ASR9

SSM-ASR9-018

SAFETY MODIFICATION SAFETY ANCHOR BRACKET WORK POSITIONING

11/22/2004

Figure 1. Bracket Positions on the Antenna

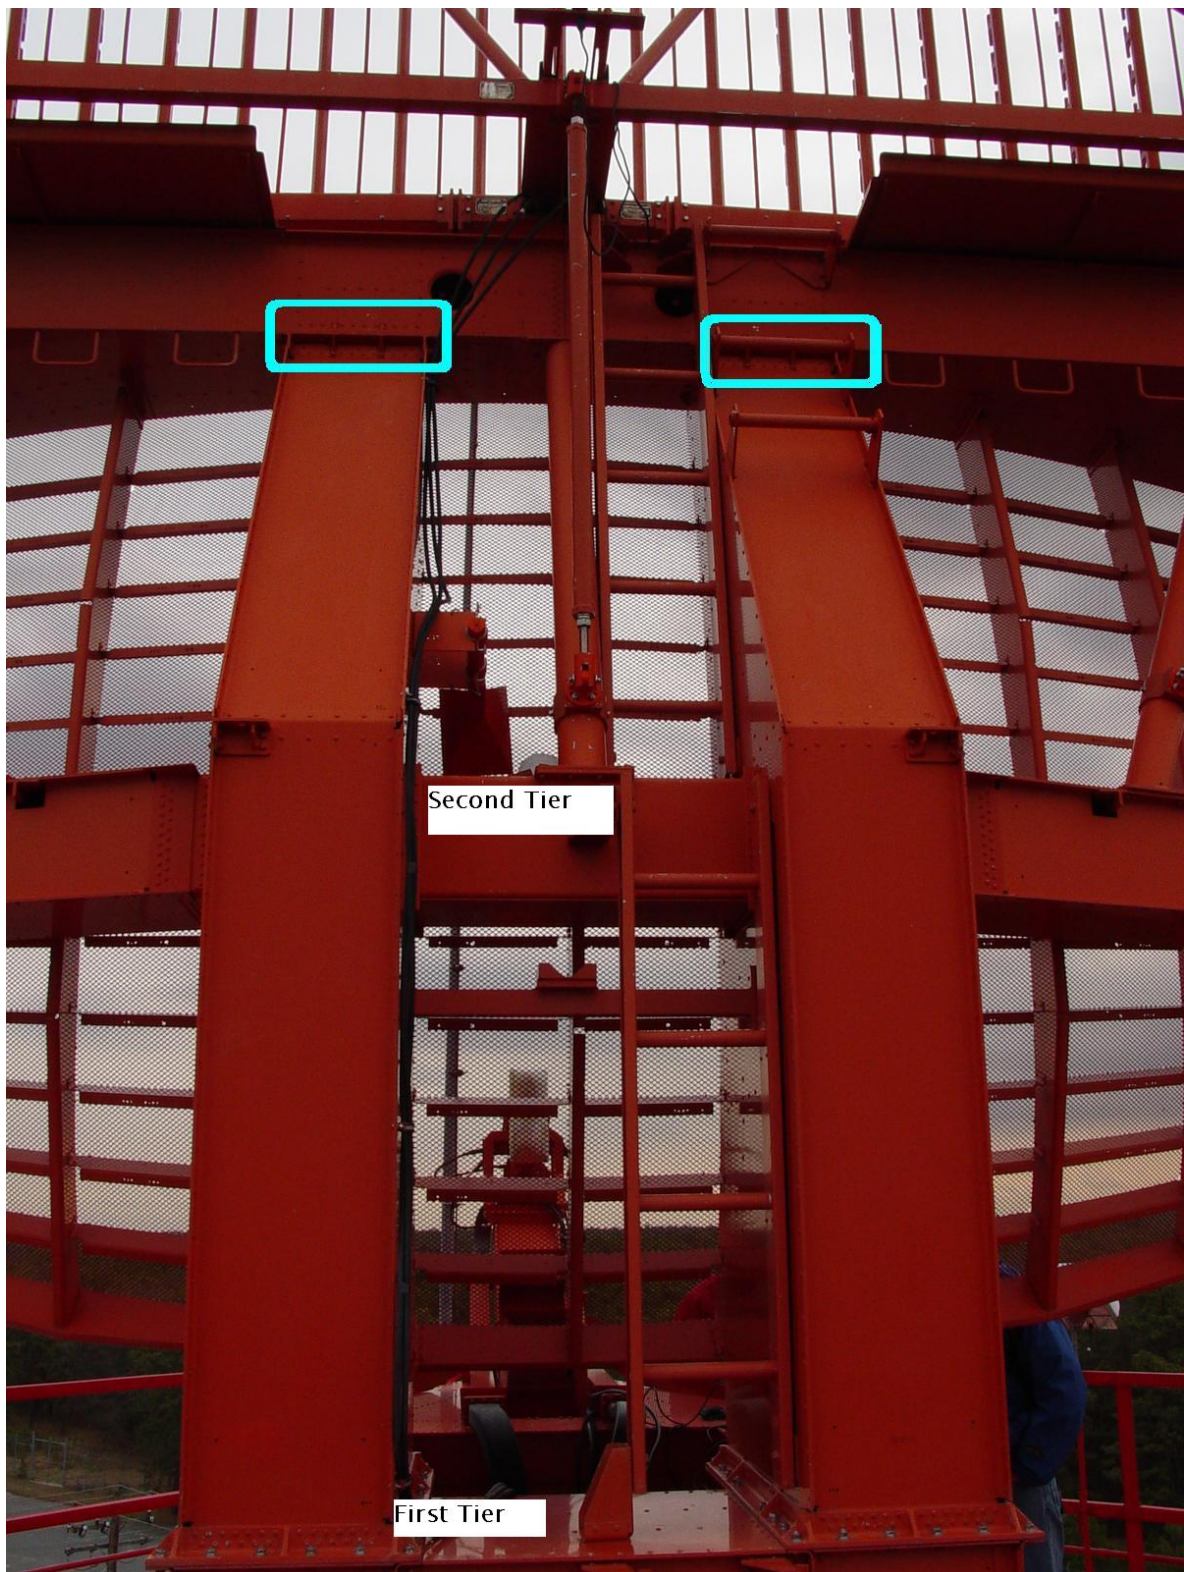
- d. Follow OSHA requirements for fall protection, put on safety harness with work positioning cable.
- e. Climb ladder located on the back of the ASR-9 Antenna, to the second tier. (Figure 1)

Figure 2. Bracket position Right

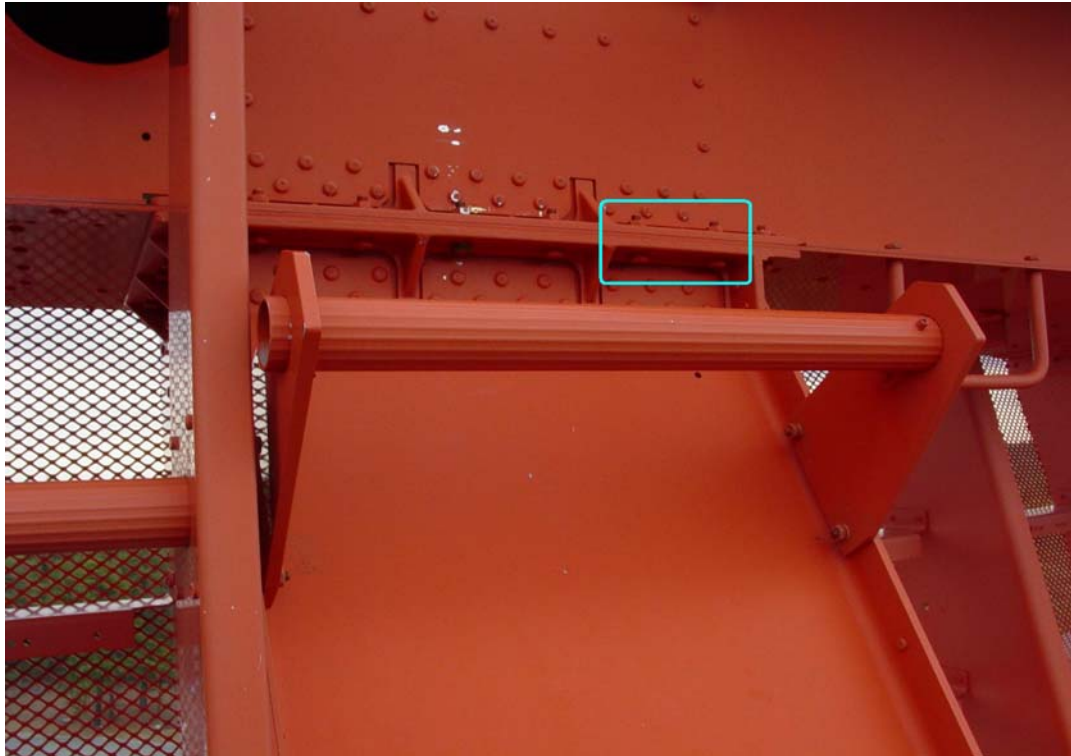
- f. Secure safety harness around ladder as a temporary measure.
- g. Remove the two bolts from either designated areas (Figure 2 or 3). Due to possible corrosion, bolts could be stuck. Apply WD-40 or similar product and allow to penetrate until bolt can be freed. Tap lightly with hammer too loosen any remaining corrosion. Take care not to distort bolts in the process.

- i. Repeat steps (g) and (h) to install the second bracket. (Figure 2 or 3)
- j. Use the paint bottle supplied to touch up the installation hardware with the Intl' Orange paint. Let paint dry for 15 minutes prior to antenna start up. Final product should resemble those in Figure 4 and 5.

Figure 5 (Right side)

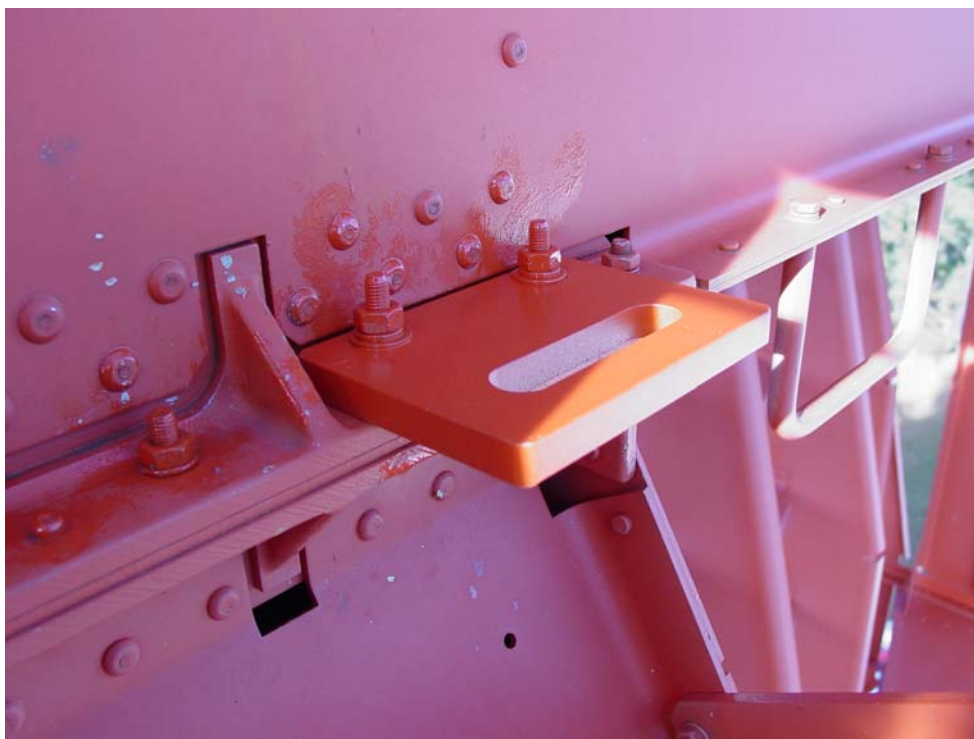
- h. Fit bracket over rivet hole and slide a new bolt (with washer) into bottom hole facing upwards. Then add the second washer, lock washer and then nut. (Figure 4 and 5) Once both bolts have been added, proceed to tighten down to a torque rating of around 95 (+/- 5) inch pounds.
